**CONSENT ORDER  
ISSUED UNDER THE  
WATER POLLUTION CONTROL ACT  
WEST VIRGINIA CODE, CHAPTER 22, ARTICLE 11**

TO: Arsenal Resources LLC  
6031 Wallace Rd. Ext Suite 300  
Wexford PA 15090

DATE: October 8, 2020

ORDER NO.: 9923

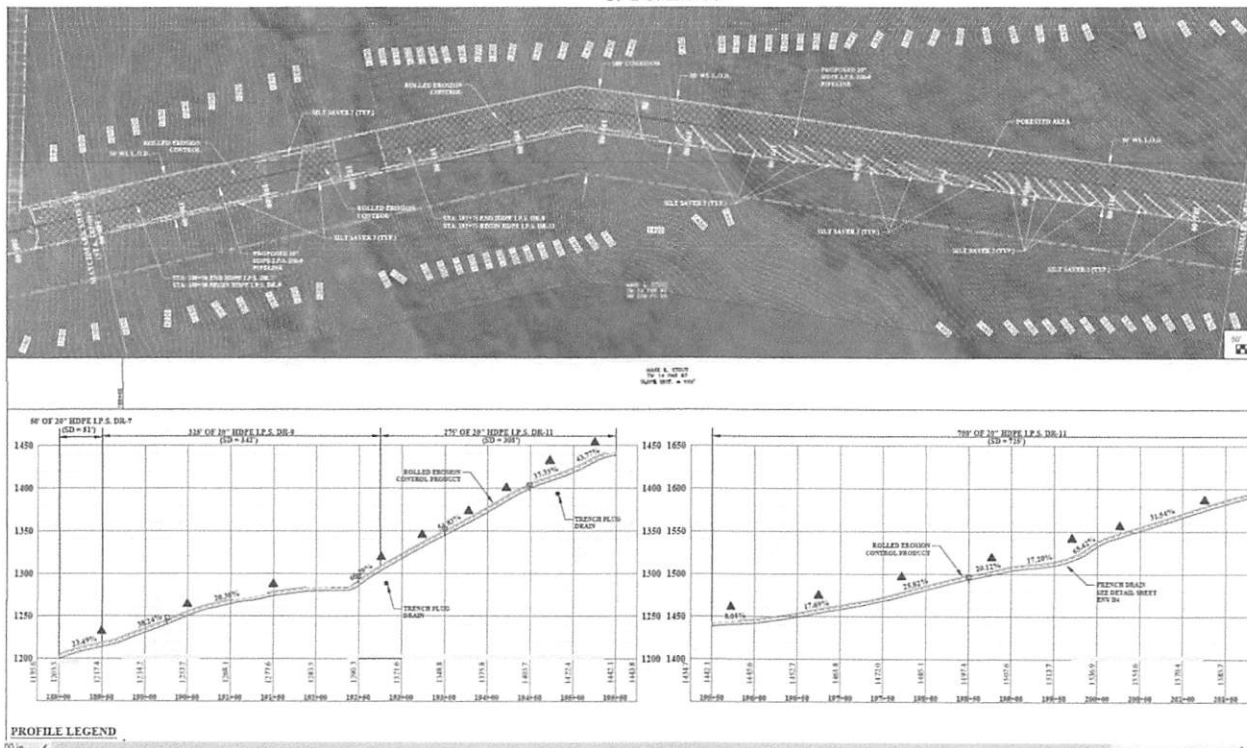
Station 192+00, Water bar terminus BMP not properly implemented, allowing sediment laden water to leave site.

No water bar terminus treatment.

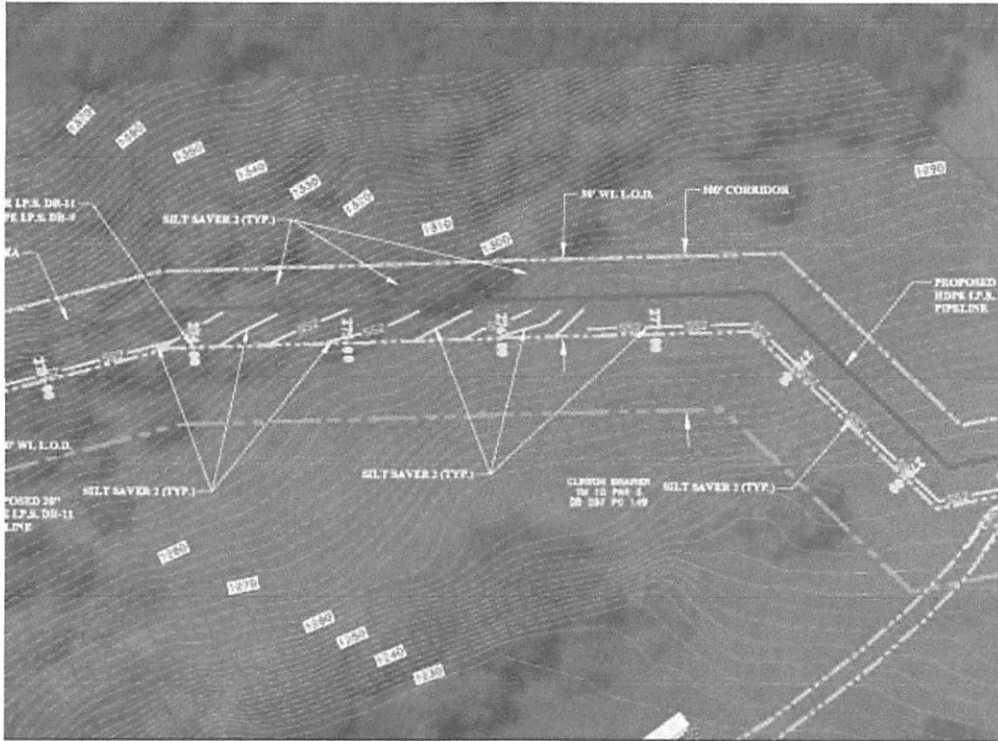
Station 260+00, SWPPP requires SS2 slope interceptors. When controls were damaged by pulling pipe strings, 8 inch CFS was installed in its place.

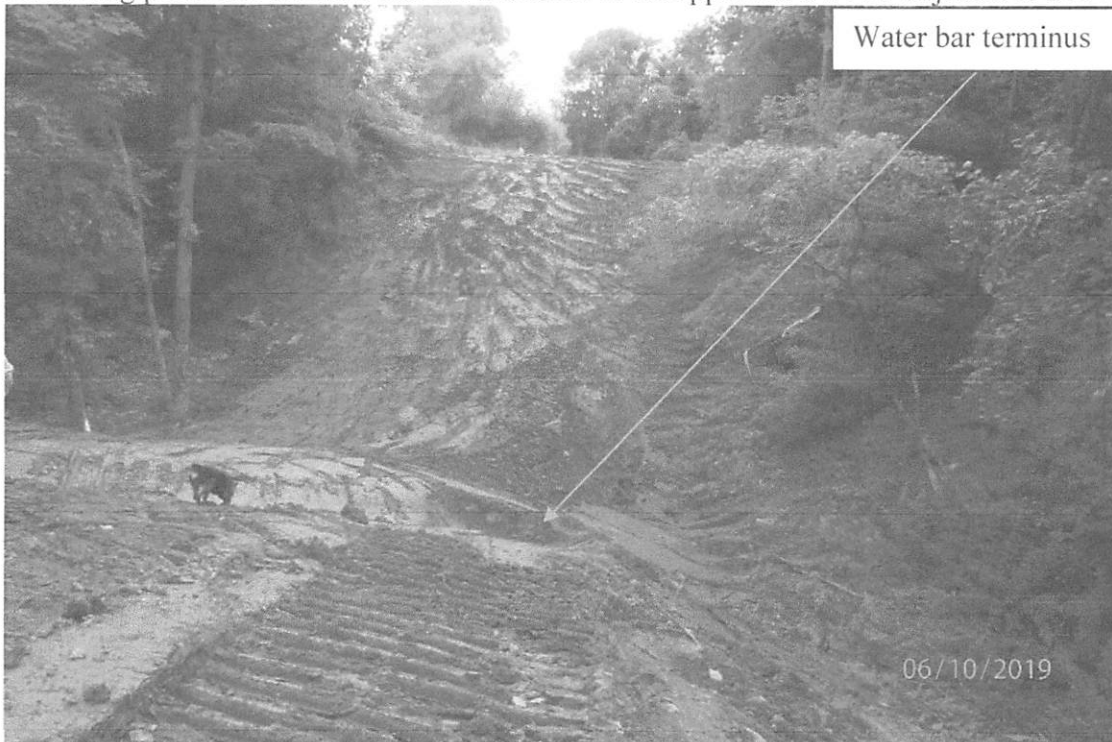
Dewatering bag in Rt. 76 conveyance.

Sediment deposit on bottom of Rt. 76 conveyance.

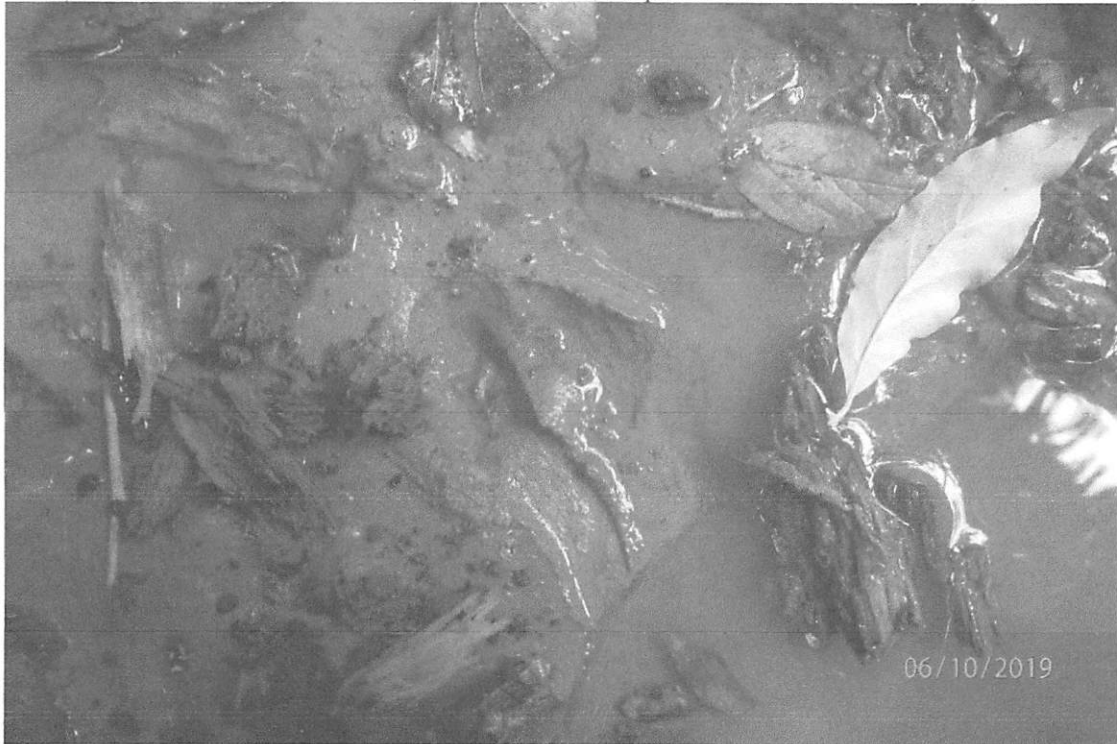
Improperly installed waterbars in the Beards Run watershed showing waterbar outlets that do not have positive drainage and allow water to flow back onto the right-of-way.

Improperly installed waterbar in the Beards Run watershed that is less than 12 inches high on the uphill side.

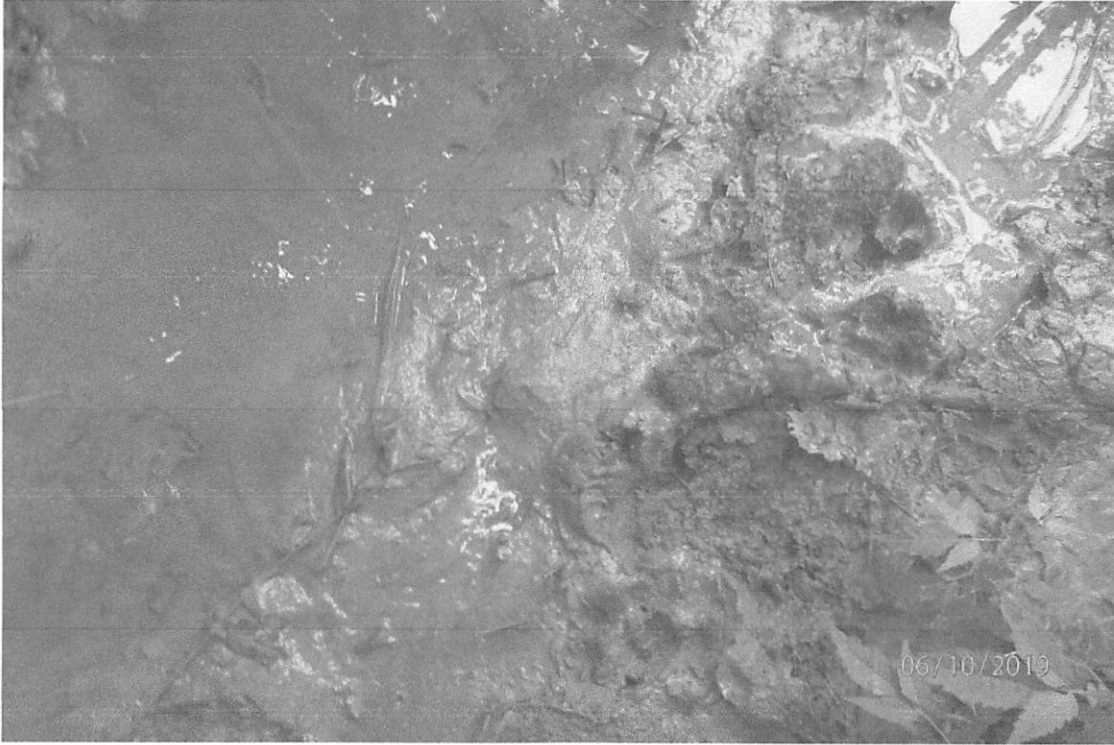
Wetland WL-28 showing an area where the approved SWPPP indicates the need for perimeter controls.

WL-28 showing the area where sediment laden water from the project is leaving the site without going through an approved device. The approved SWPPP does not indicate the need for BMPs in this area even though it is evident that a stream of water is present.

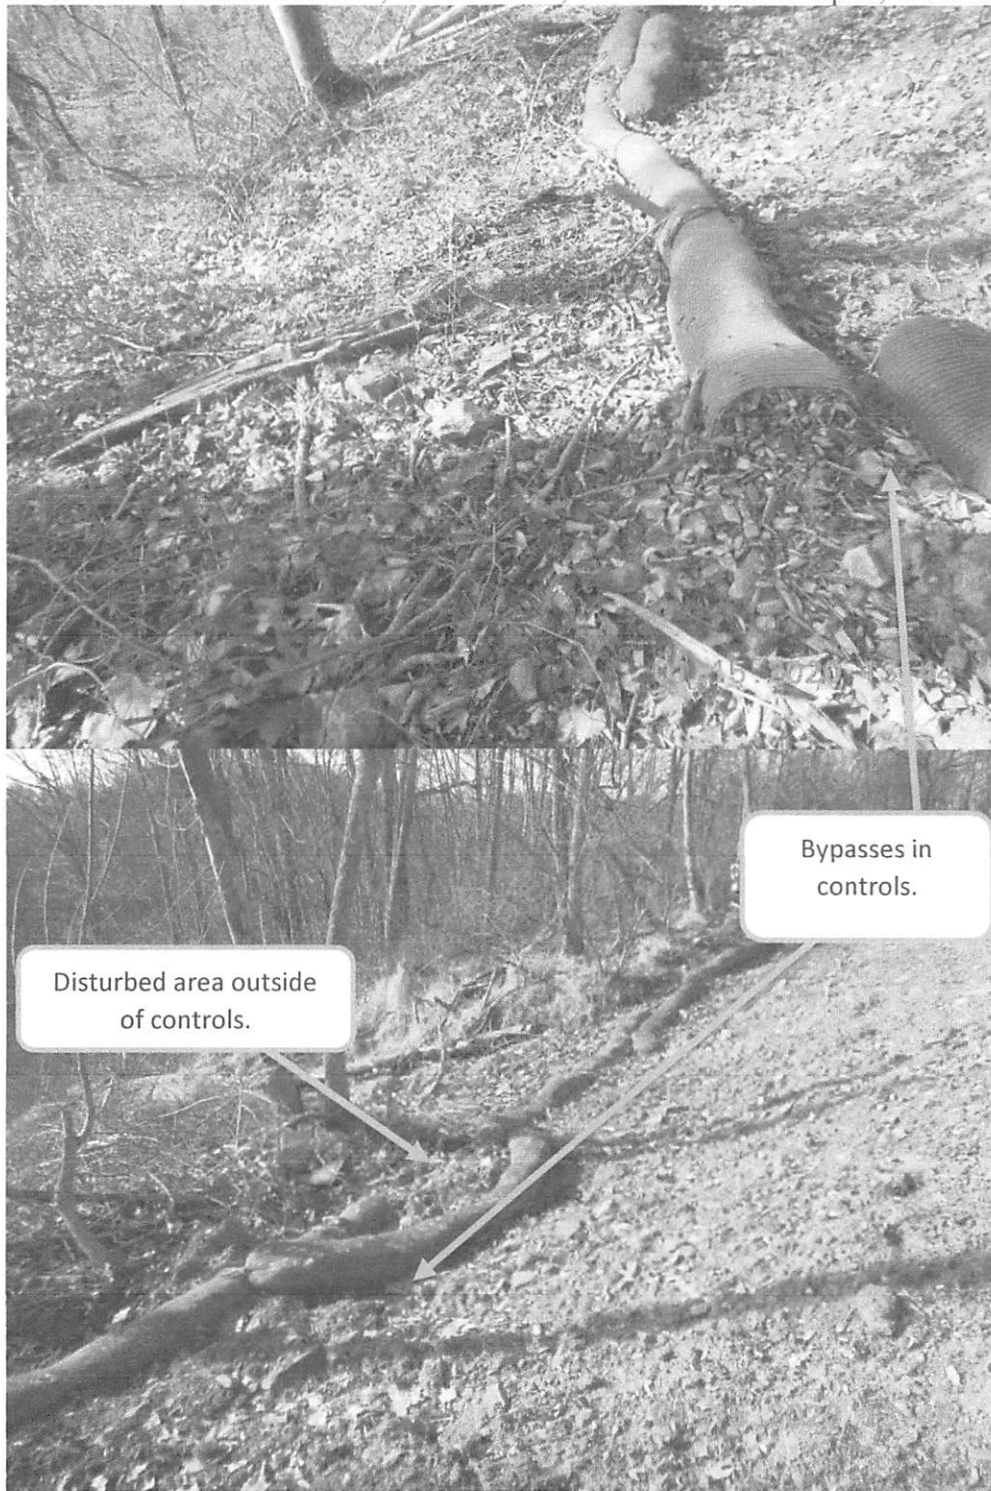
Drop inlet in concrete slurry diversion ditch with no inlet protection and sediment deposits present from unstable area above the diversion ditch.

Rolling debris from unstable area above concrete slurry diversion ditch.
